Arnside Silverdale AONB -- DPD -- 12th July 2017

Consultation on additional possible development sites

Response from Silverdale Parish Council

Site S 50 -- Off St Johns Avenue, Silverdale

FLOUDING, ATRENT TO SITE 50. Cemetry wall and Rottoms LANG. S176 50

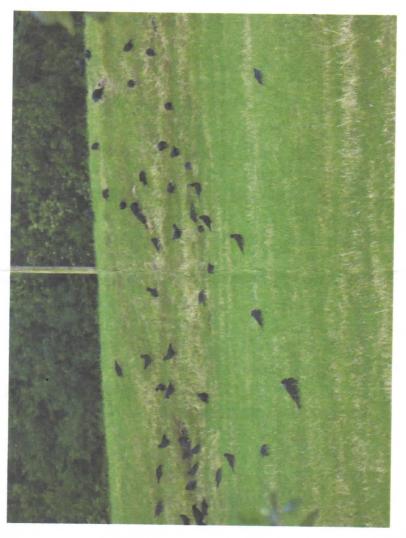
- 9. Surface water flooding in the vicinity of the site has been clearly evident in recent years. The natural lie of the land falls away northwards towards the Cemetery. Just outside the Cemetery is a low lying area of agricultural land that regularly does not drain away after any significant rainfall. This is reported to have caused a planning application for extension of the Cemetery to be refused due to risk of water-logging. This low lying area continues at a slightly lower level still over and beyond Emesgate Lane into the area of Townsfield and through to the rear of Cove Road. Properties in this zone have for many years had issues with their private Wastewater system being back filled with surface water via their drainage / infiltration fields, causing sewage to back up into the interior property fittings and, in some cases, basements. This has been a major inconvenience and a potential health hazard. At one time it is reported that Lancaster City Council contracted with United Utilities to regularly pump out Septic tanks in this area to help reduce the issue until cost cutting resulted in the

service being stopped. The additional flow of wastewater, together with runoff from the inevitable hard surfaces of this proposed site which would flow into this already problematic, low lying area, suggest that no further development should be contemplated until both the Wastewater systems for the area and surface water drainage are agreed to have been robustly resolved. Attached is a appended copy of a Map showing known details of flooding in the area together with information about an underground water flow route.
